**Item No. 13.1.5**  
**Halifax and West Community Council**  
**December 15, 2021**

**SUBJECT:** **Cases 23746 & 22896: MPS and Development Agreement Amendments for Seton Ridge - Bedford Highway, Seton Road & Lacewood Drive, Halifax**

**Proposed Amendments to the Halifax Municipal Planning Strategy**

Bedford Highway Secondary Planning Strategy  
**Map 9Df – Seton Ridge Neighbourhood Plan**

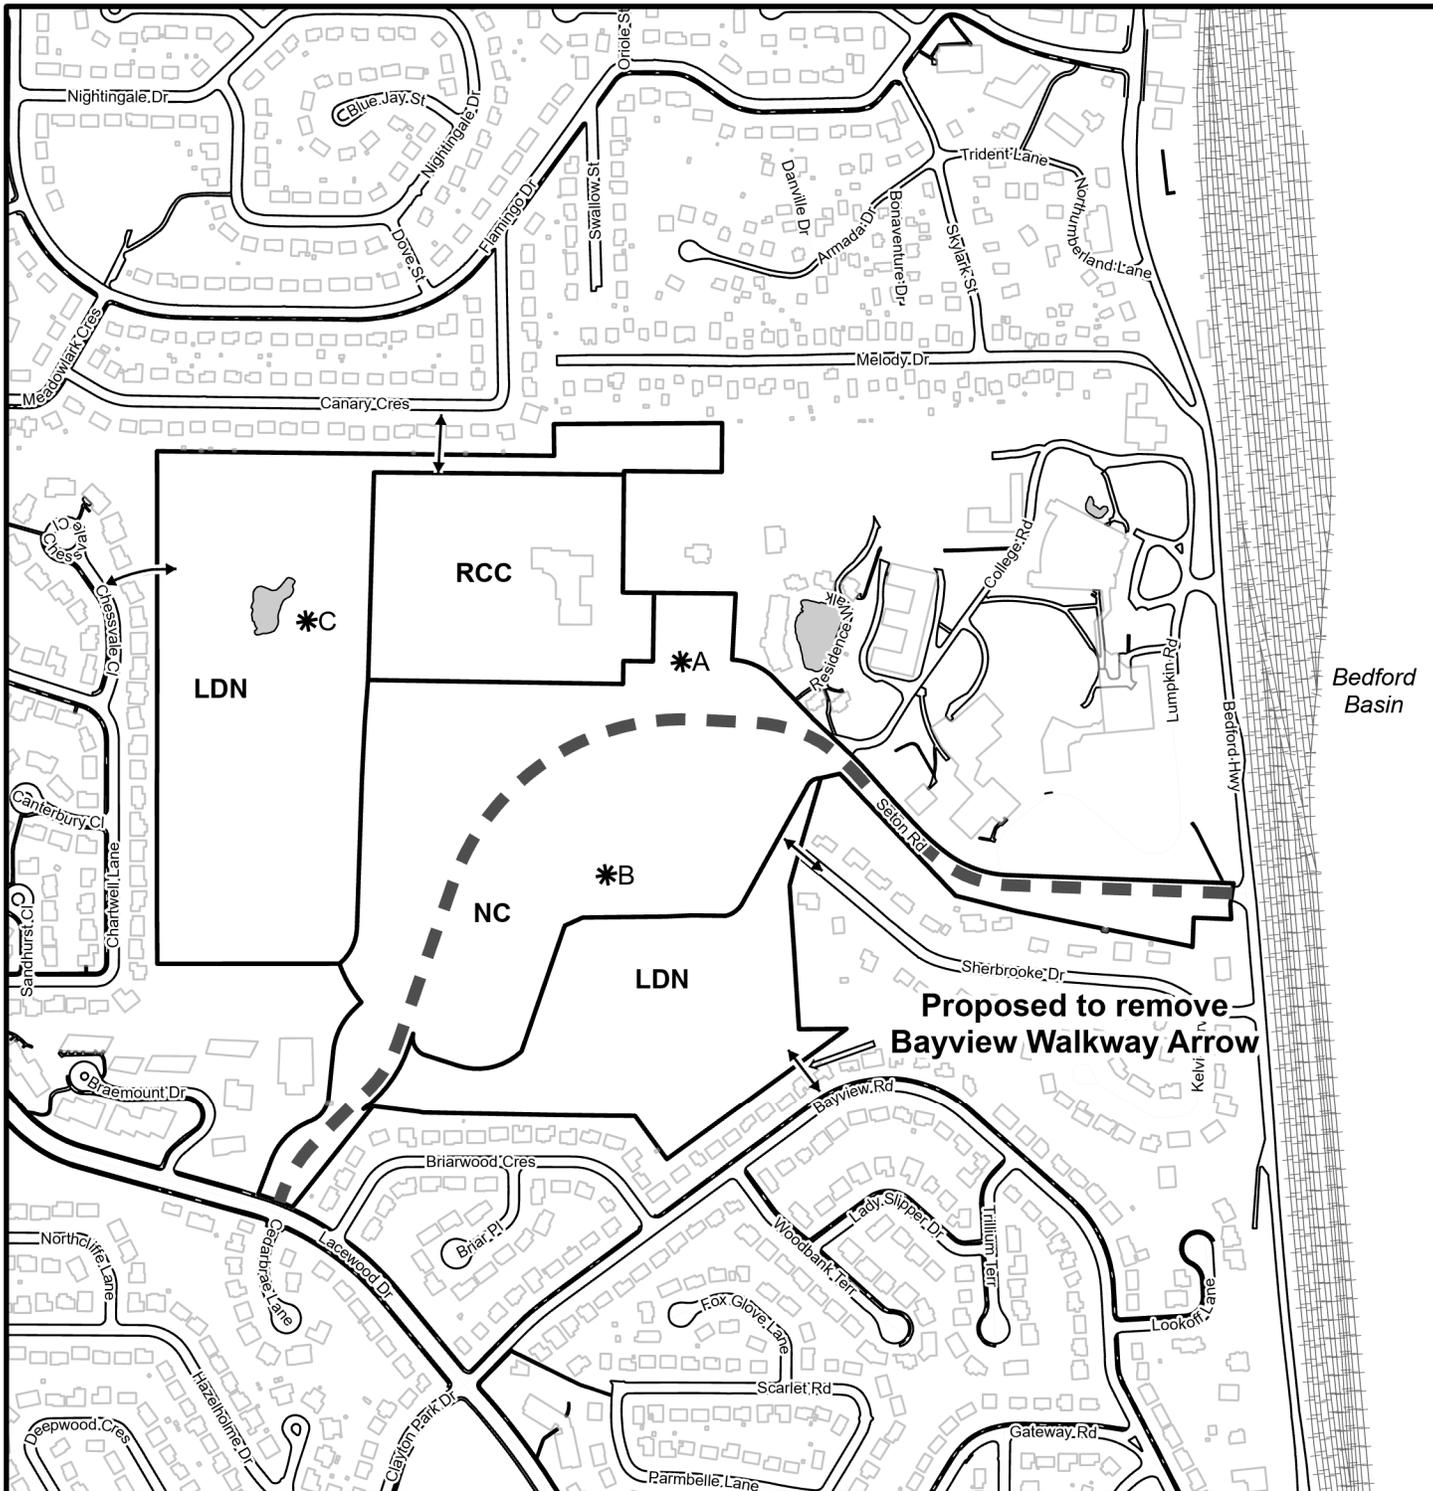
1. Map 9Df of Section VIII (Bedford Highway Secondary Planning Strategy) shall be amended by deleting the arrow which denotes the walkway connection between the Seton Ridge lands and Bayview Road, Halifax, as shown on Schedule A attached hereto.

**Proposed to remove Bayview Walkway Arrow**

# Schedule C2A - Site Plan

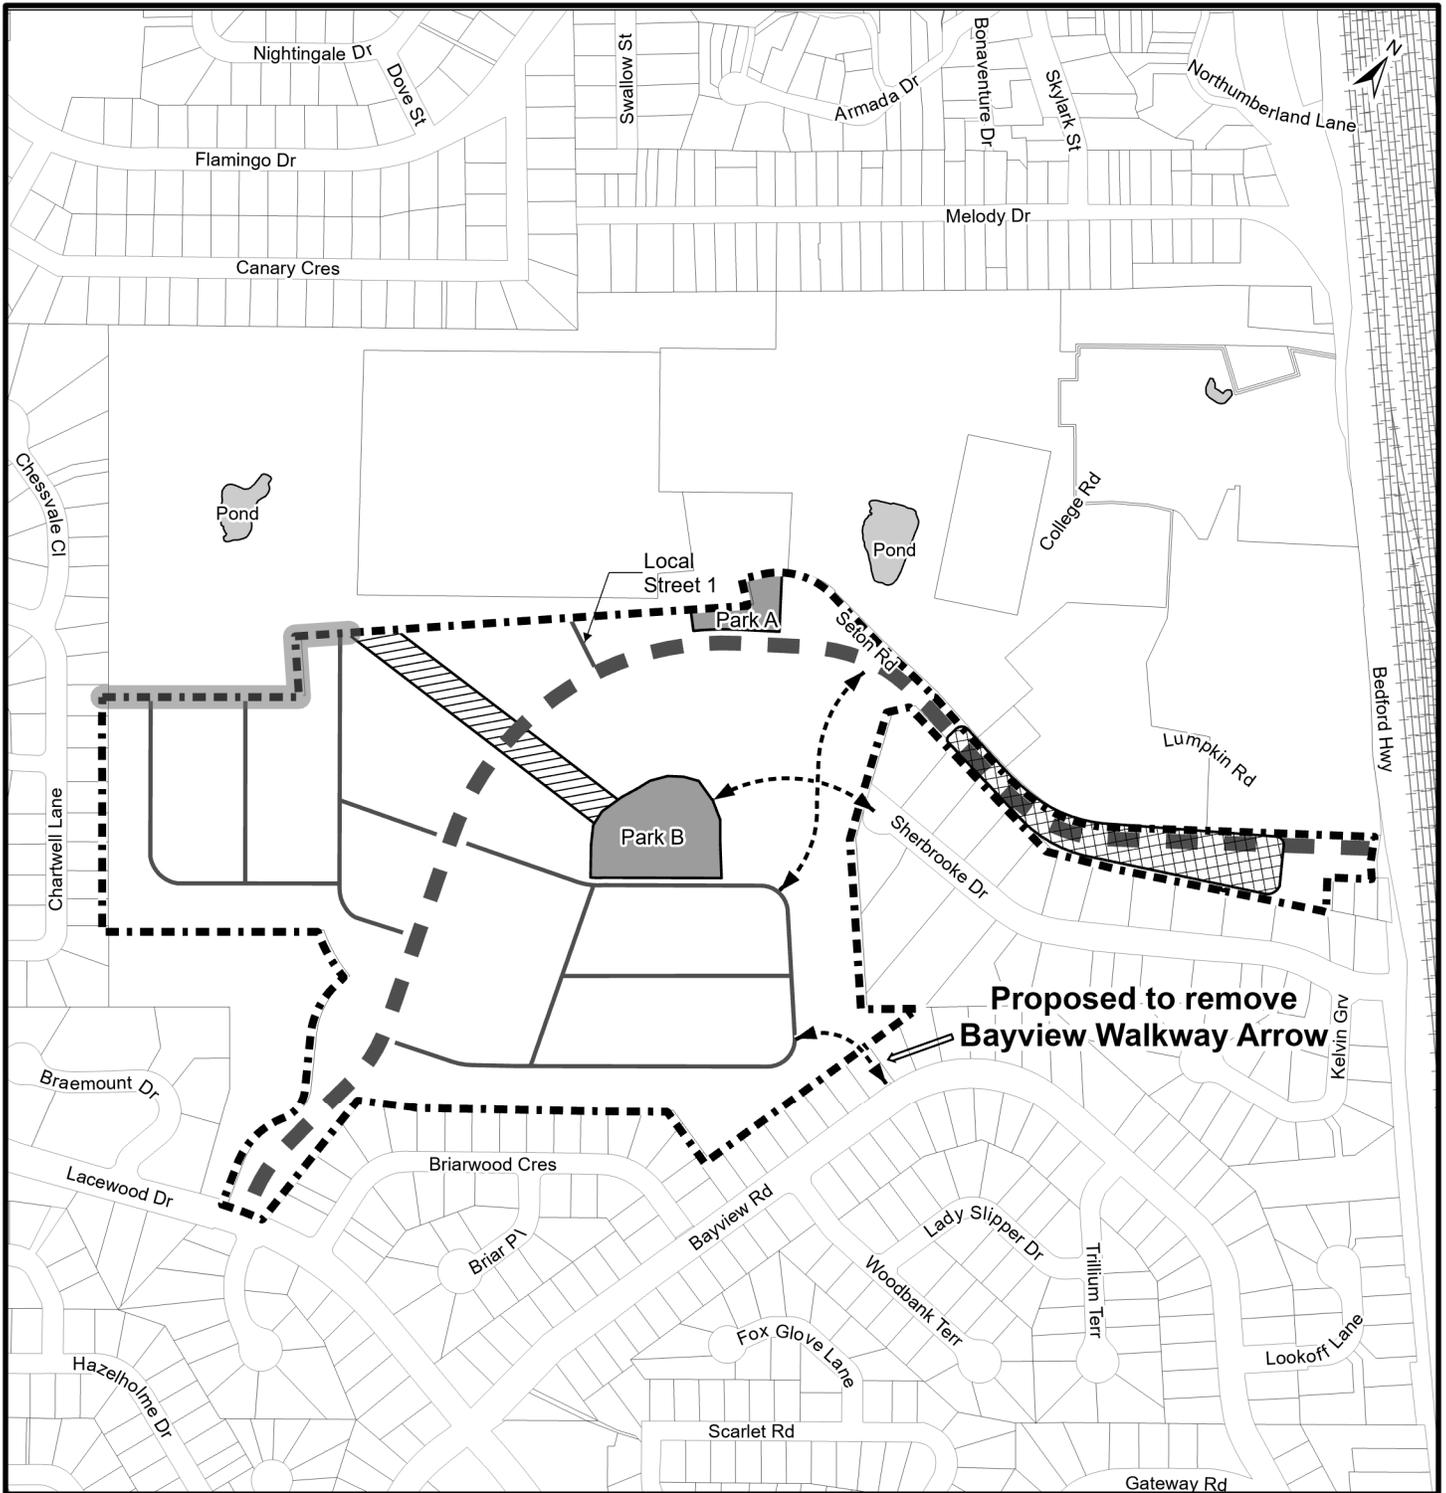
5. The Original Agreement shall be amended by deleting the following Schedule:

Schedule C2            Site Plan

And inserting the following Schedule:

Schedule C2A            Site Plan (attached)
